File Numbers: 26T19-02-18 (Draft Plan of Subdivision)
OP-AM-03-18 (Official Plan Amendment)
AM-04-18 (Zoning By-law Amendment)

RE: Saffron Meadows Phase 3 development (Resubmission 2)
162 Port Robinson Road
Part of Thorold Township Lot 171-172, and Part 1 on RP 59R-3218
Roll No. 2732 030 020 07600 + 2732 030 020 08700

Town Planning Comments (2nd)

CONSULTANT FILE NO. 1541	REV. 0
DATE 2018-04-26	1541-SP178
PRINTED 2018-04-26	
SCALE 1:500	
SHEET No. .

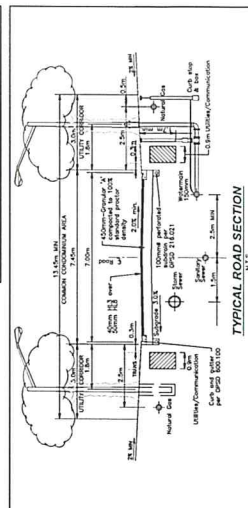
The agent submitted preliminary site plans illustrating the private road layout and townhouse units of Blocks 177 and 178. Condominium townhouse developments are able to receive internal curbside garbage collection through the Region. In order for this service to be provided, the developer/owner shall comply with the Niagara Region's Corporate Policy for Waste Collection and complete the Application for Commencement of Collection and an Indemnity Agreement. The forms and policy can be found at the following link:
www.niagararegion.ca/waste.

- Block 177
 - Due to proposed internal roadway design, Regional waste collection staff require the inclusion of waste collection pads for Units 1, 2, 9, 10, 17, 18, 34, 35. These collection pads should be placed close to corners of the internal roadway intersections.
- Block 178
 - Regional waste collection staff have reviewed the submitted site plan and note the requirement of waste collection pads for Units 1-4, 65-72, and 86. Further, staff request that the applicant include waste collection pads for Units 5, 73 and 85 so waste collection trucks can make complete loops and negate the need for any reverse motion.
